ET-NRC-93-3795
NSRA-APSL-93-0006
Docket No.: STN-52-003
Proj 076
January 14, 1993

SUBJECT: WESTINGHOUSE RESPONSES TO NRC REQUESTS FOR ADDITIONAL
INFORMATION ON THE AP600

**ET-NRC-93-3795
ATTACHMENT A
AP600 RAI RESPONSES
JANUARY 14, 1993**

Figure 3E-1 (Sheet 1 of 10)

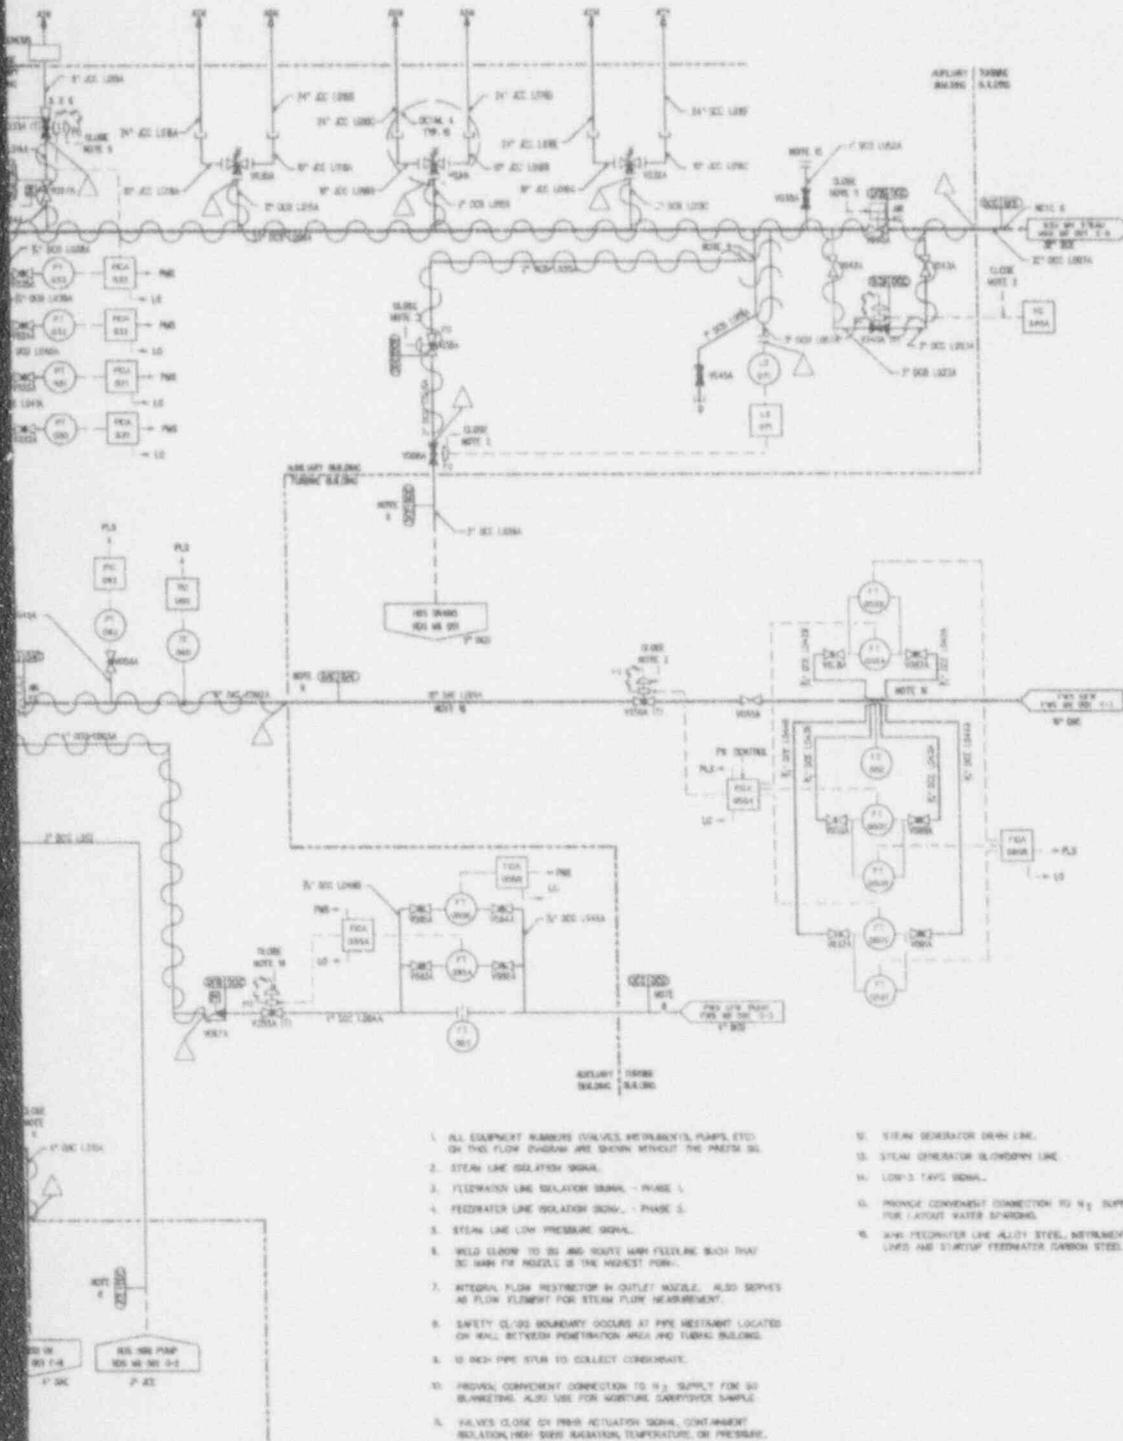
Question 210.6

SSAR Subsection 3.6.2.1.1 will be revised and Appendix 3E added as follows:

This appendix identifies high-energy piping in the nuclear island with a diameter larger than 1 inch. Candidate leak-before-break piping is identified in Figure 3E-1 along with other piping for which high-energy pipe failures are postulated. The selection of the failure type is based on whether the system is high or moderate energy during normal operating conditions of the system. High-energy piping includes those systems or portions of systems in which the maximum normal operating temperature exceeds 200°F or the maximum normal operating pressure exceeds 275 psig. Piping systems or portions of systems pressurized above atmospheric pressure during normal
